Packet Guide
City of Charlottesville
Board of Architectural Review
Regular Meeting
November 18, 2025 5:30 p.m.
Hybrid Meeting (In-person at Council Chamber and virtual via Zoom)

**City of Charlottesville
Board of Architectural Review
Staff Report
November 18, 2025**

BAR # HST25-0110

**City of Charlottesville
Board of Architectural Review
Staff Report
November 18, 2025**

A2.1

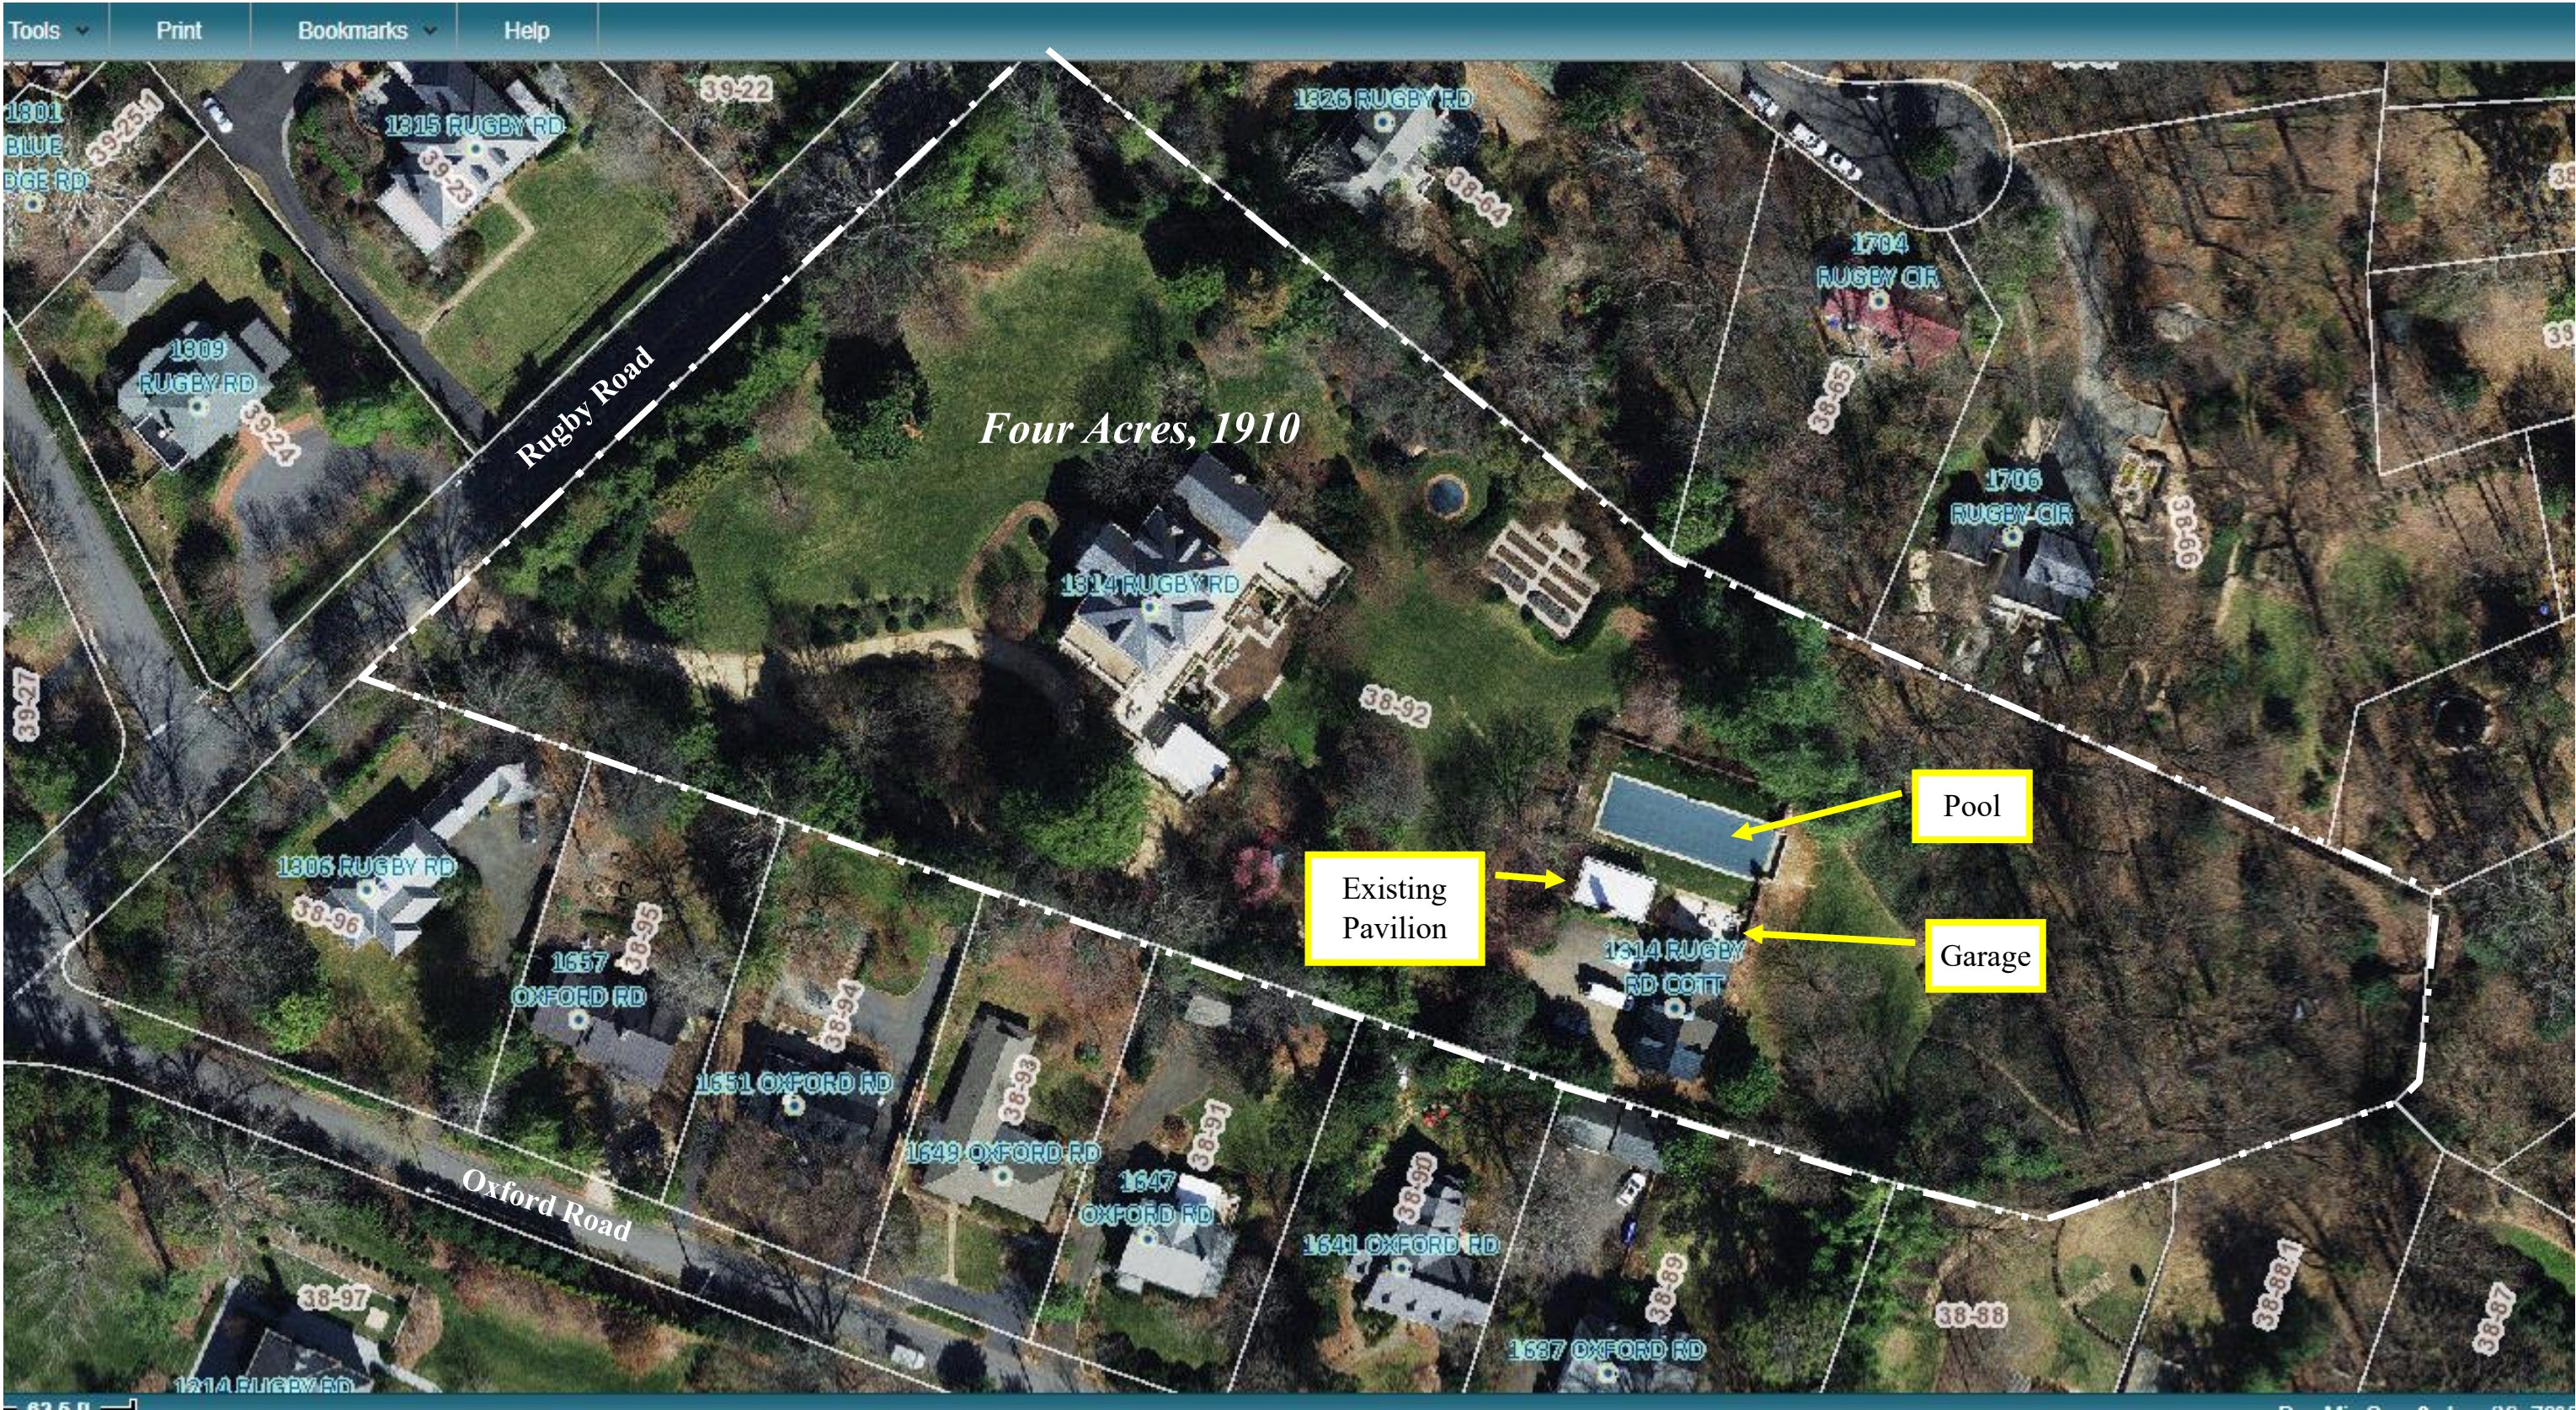
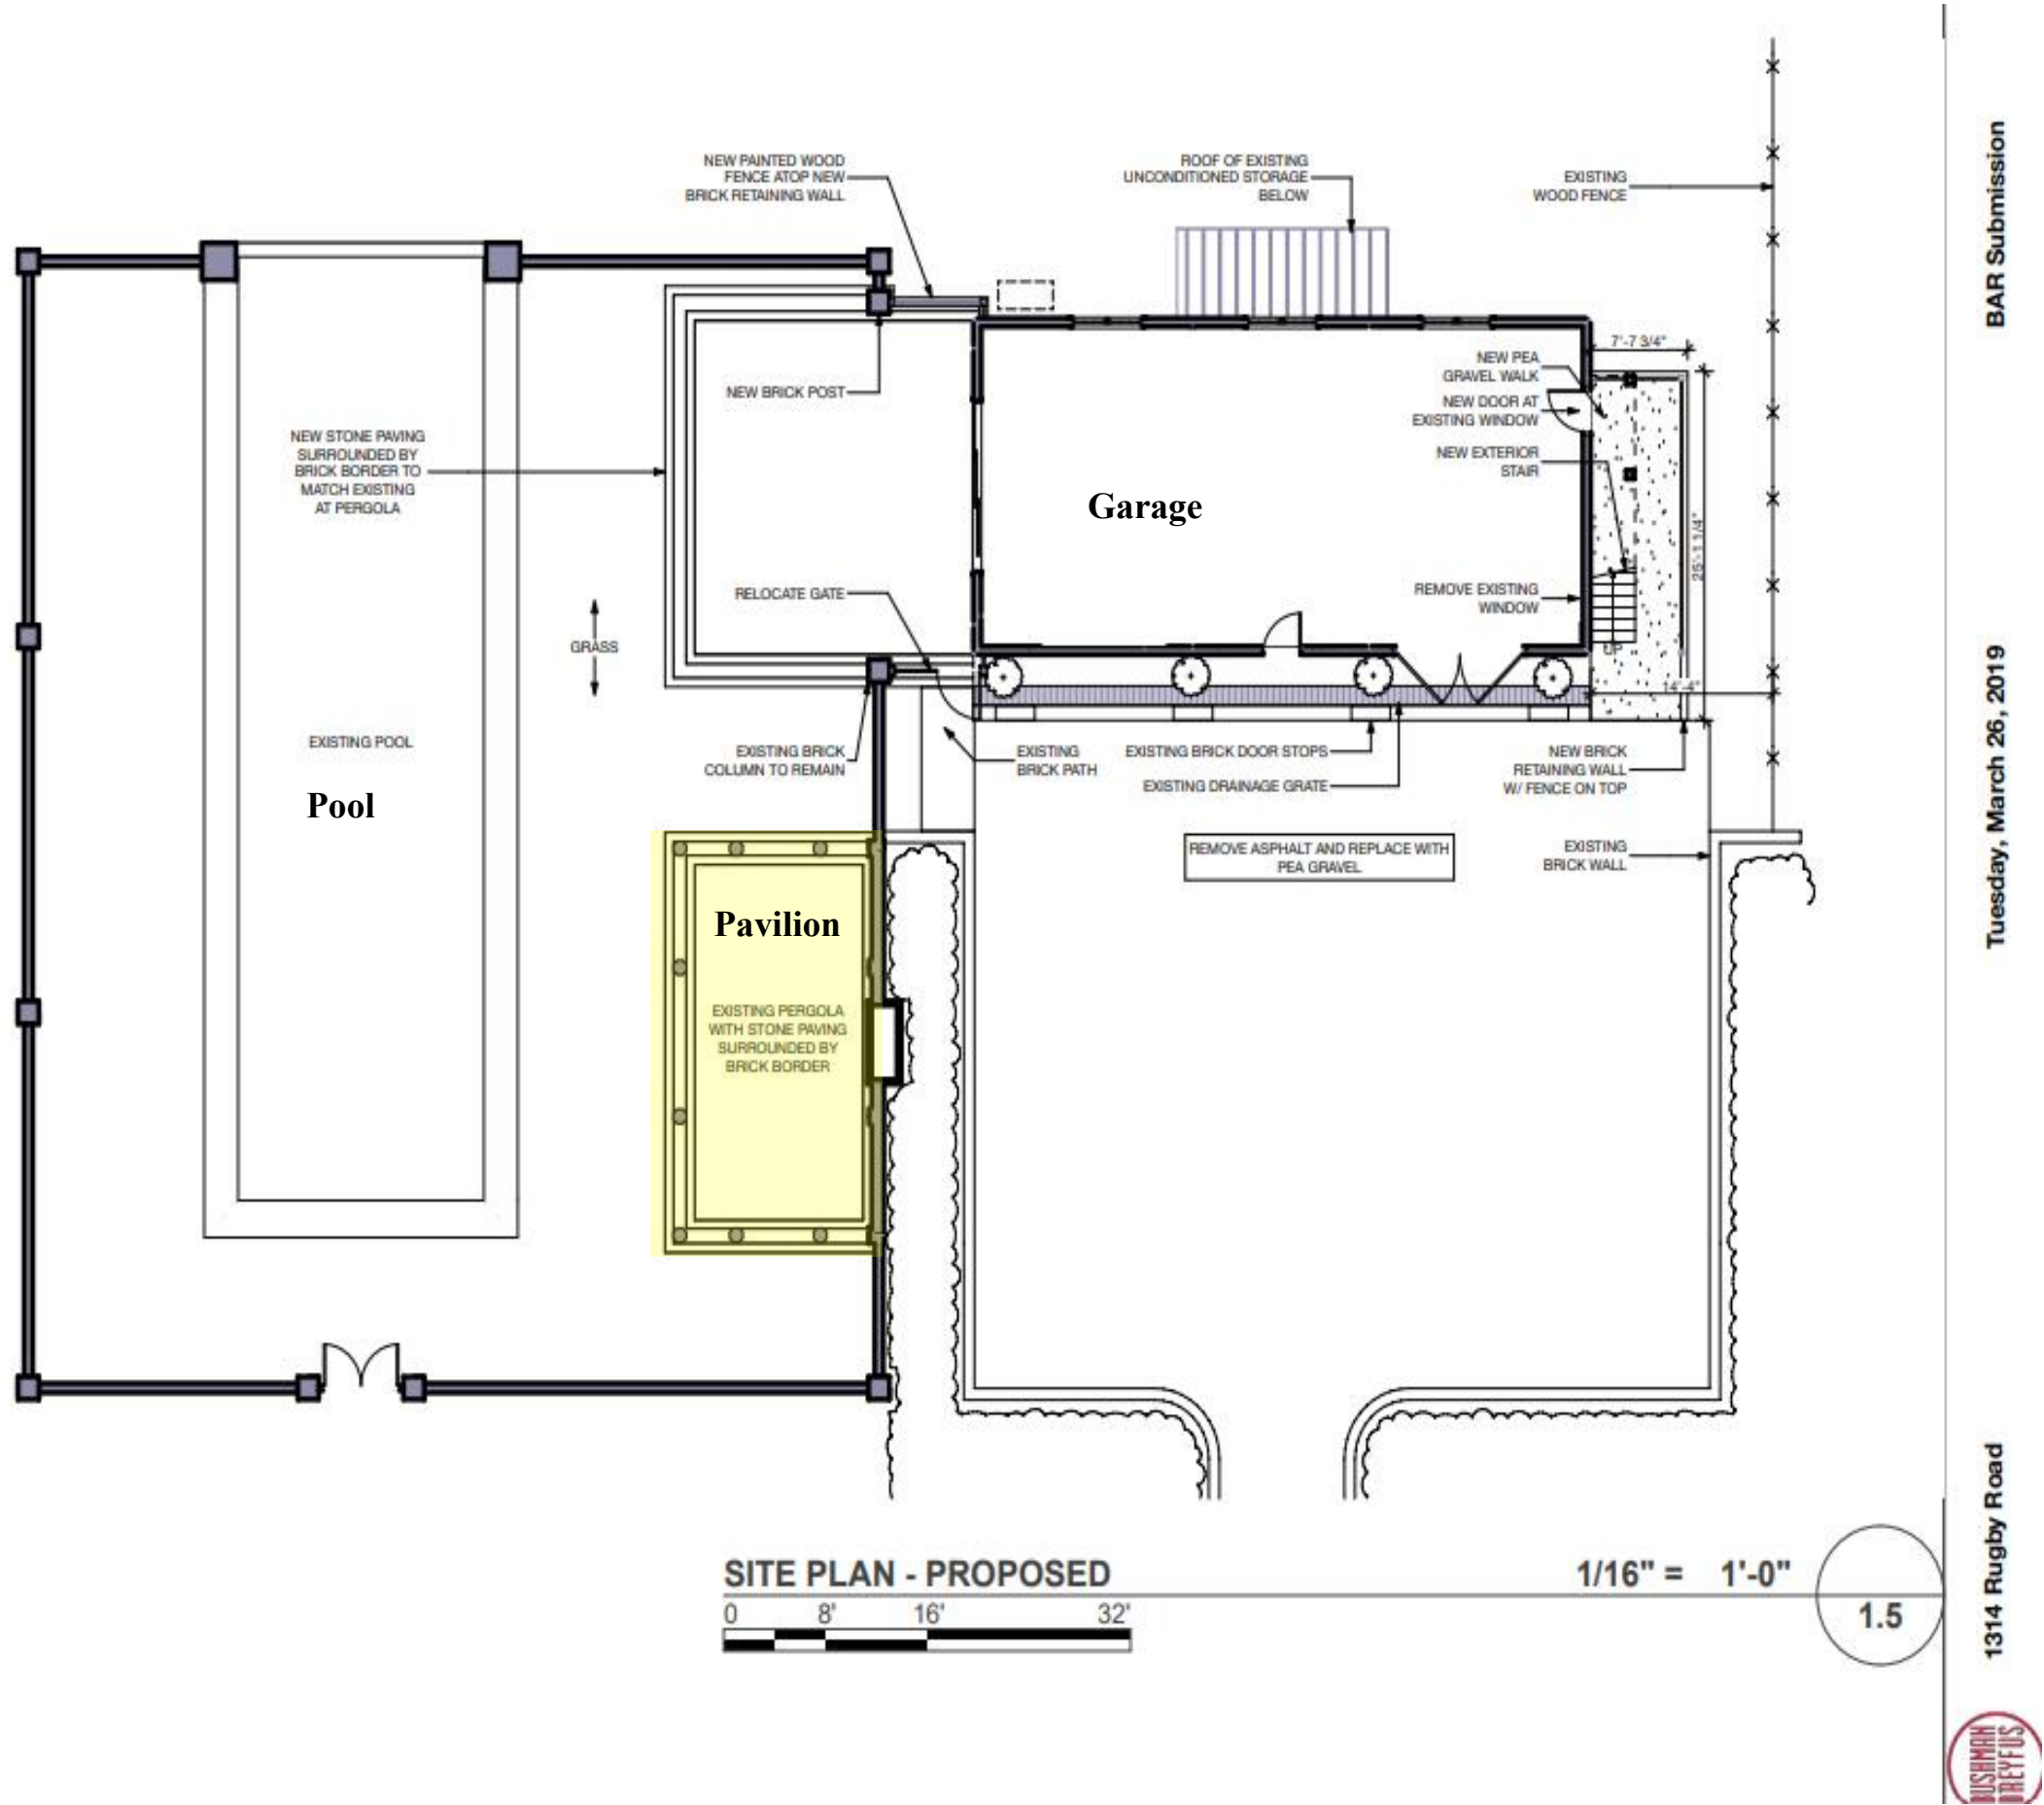
Staff recommends approval as submitted. The existing pergola is not historic. The pavilion design not out of character with the historic house, and is consistent with the adjacent garage, the most prominent nearby structure.

FRONT PORTICO BASEMENT WINDOWS -

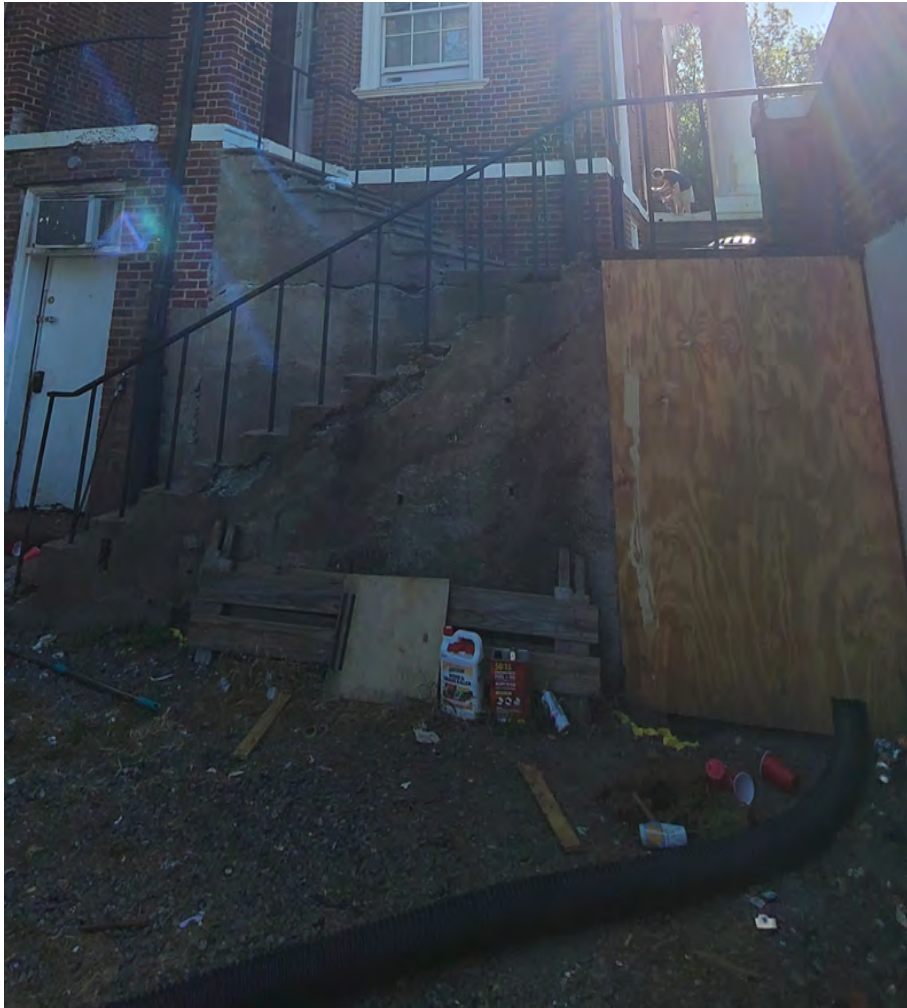
- Existing railings will be reused; however, if existing are salvageable, the new will reasonably replicate the existing, with the understanding that dimensions might be modified to meet code requirements.
- Approval of the infill with brick the three, basement-level windows at the front of the porch with the condition that the coursing, brick color and mortar be matched as closely to the historic as possible, and that the brick infill be set back several inches from the plane of the brick wall.
